THE ROYAL GOLF CLUB AT LAKE ELMO

CLUBHOUSE ADDITION

Re: Sketch Plan Review – Royal Clubhouse Expansion

TO: SOPHIA JENSEN
FROM: SARAH EVENSON, PLA
RE: ROYAL GOLF PICKLEBALL AND CLUBHOUSE ADDITION LANDSCAPE AND TREE PRESERVATION PLAN REVIEW MEMO

TREE PRESERVATION PLAN (OVERALL)

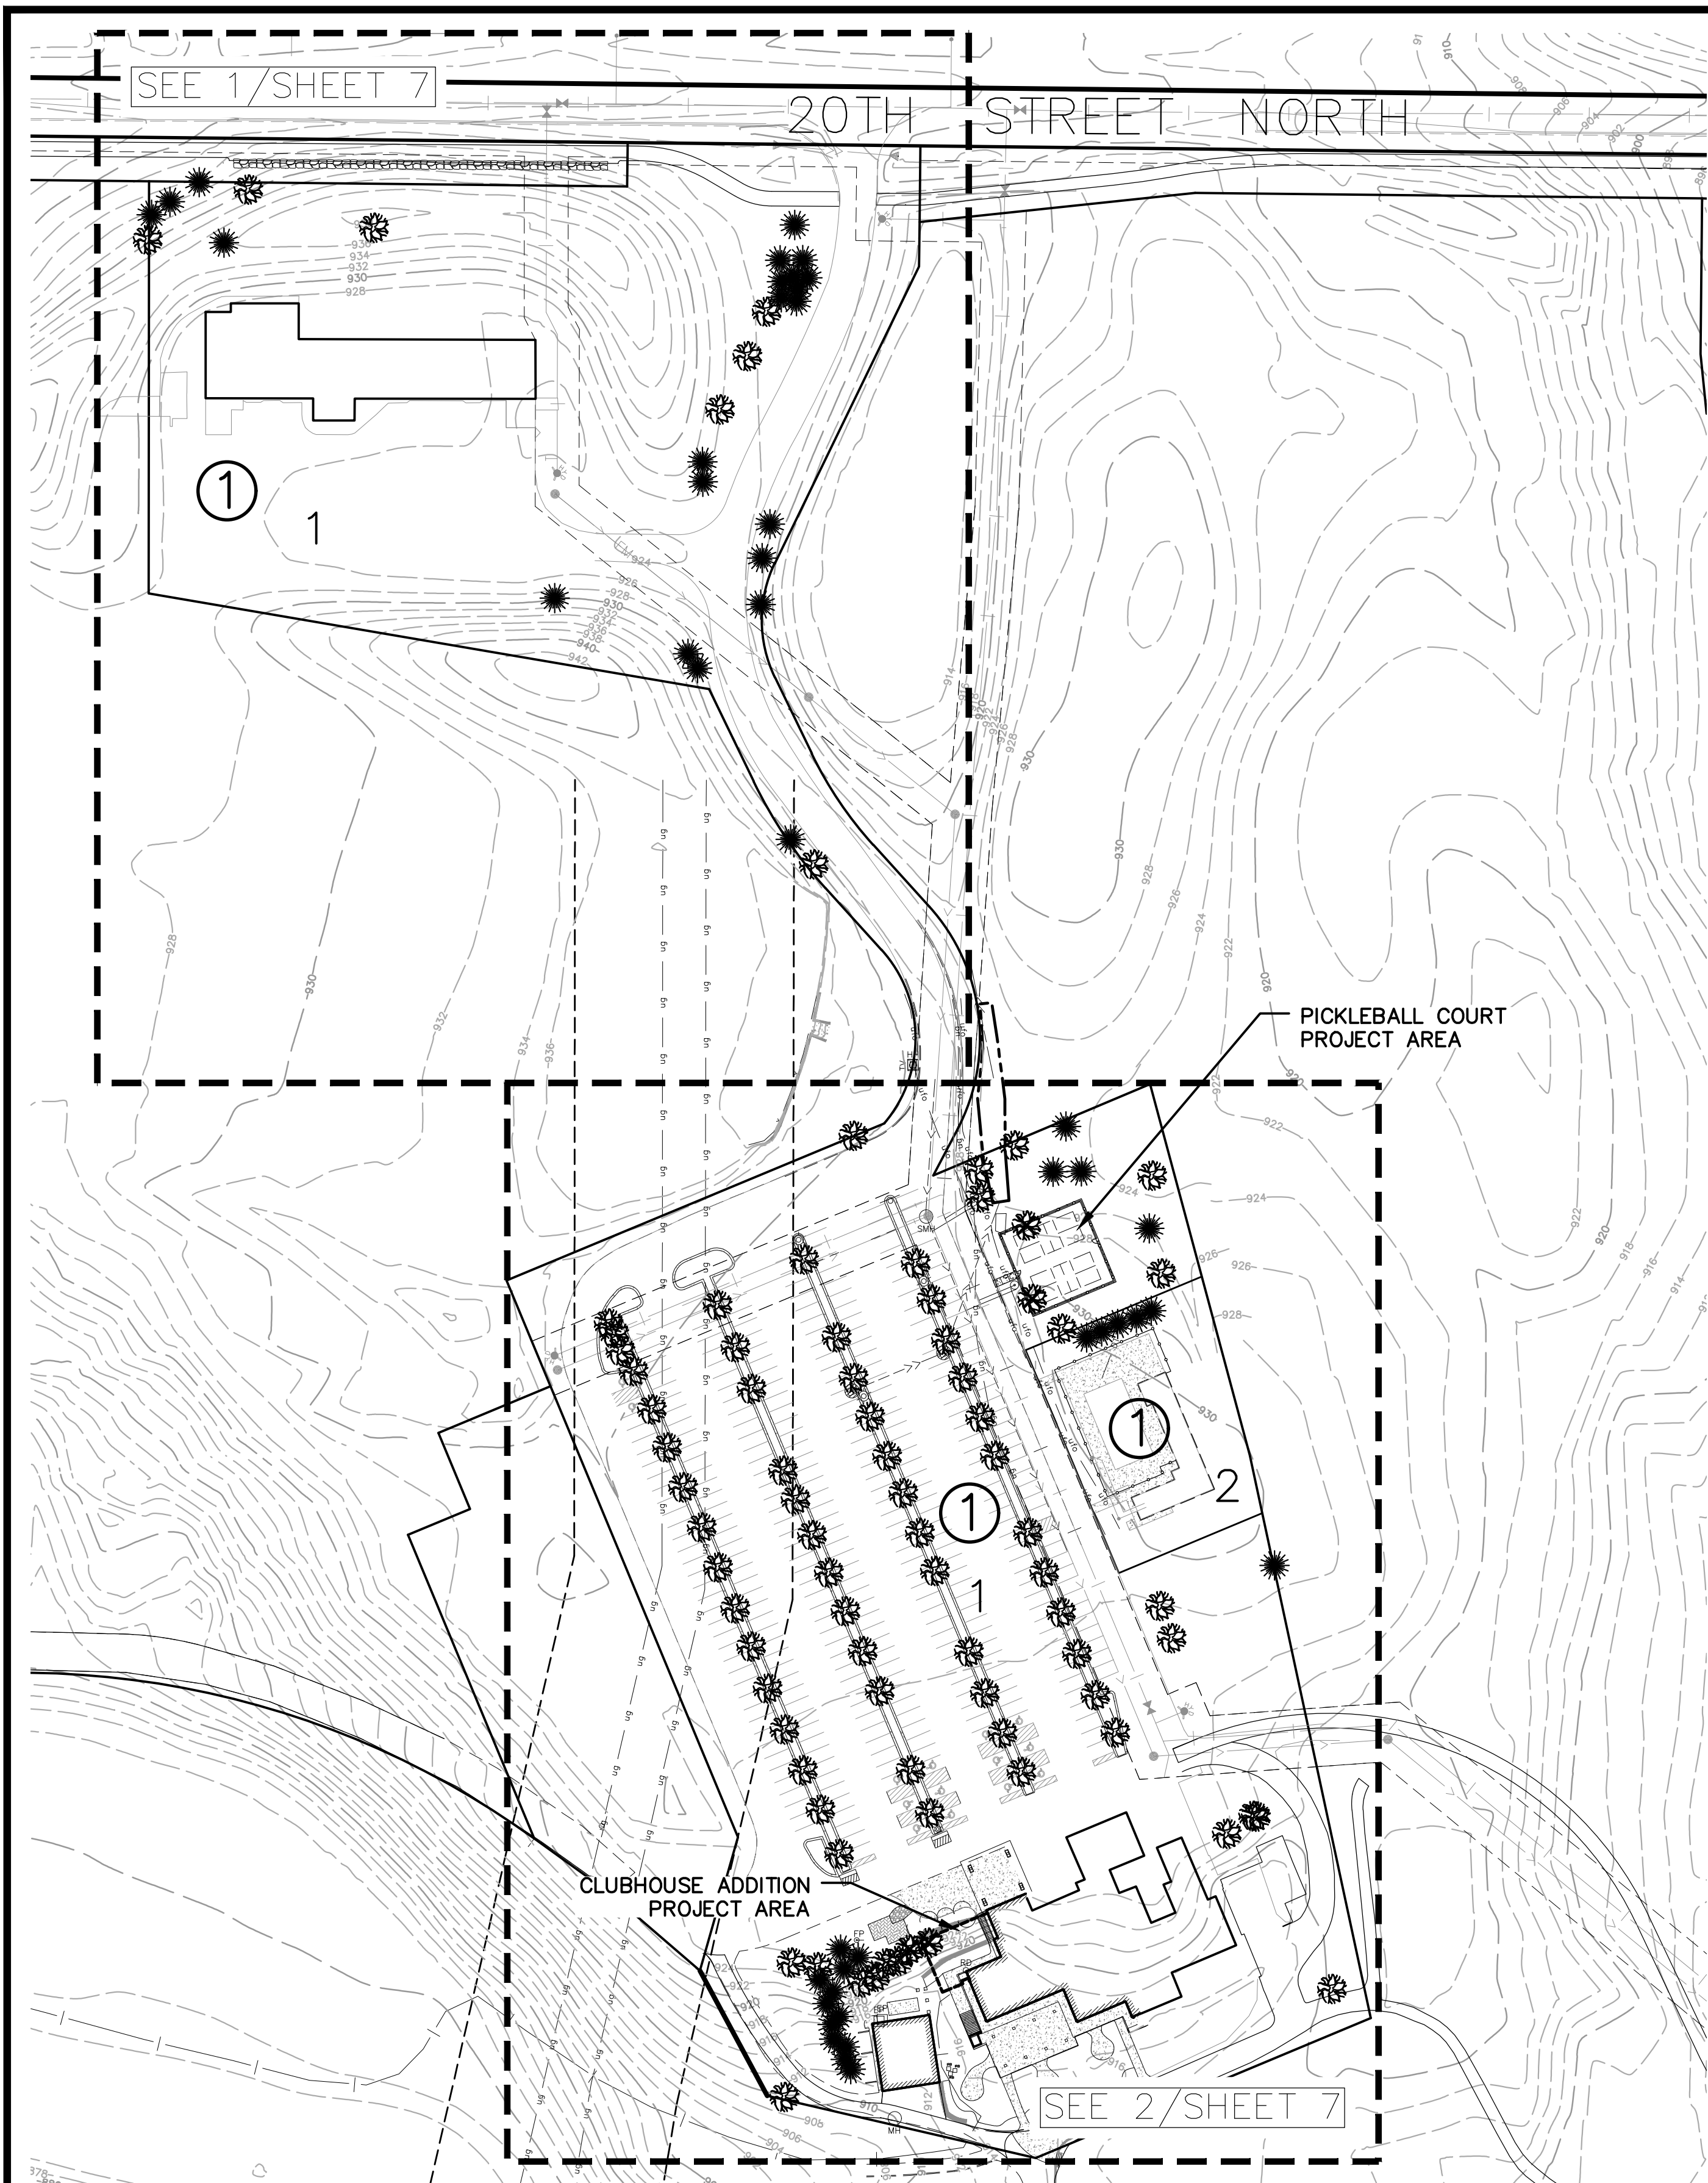
- » The applicant prepared a tree preservation plan for the parcel, which indicates that they are not planning to remove more than 30% of deciduous hardwood, coniferous, or common trees as part of the proposed pickleball and clubhouse addition projects.
- » The applicant has elected to attempt to preserve two large spruce trees north of the pickleball courts. For the purposes of the tree preservation code, they are counted as removals due to the work that will occur within their critical root zones (CRZs). The owner will remove these on their own if they do not survive.
- » The tree preservation plans for both the pickleball and the clubhouse expansion projects on the parcel now meet code, and may be approved.

- » The applicant has made the recommended adjustments to the landscape and tree preservation plans and the landscape and tree preservation plans are now recommended for approval.
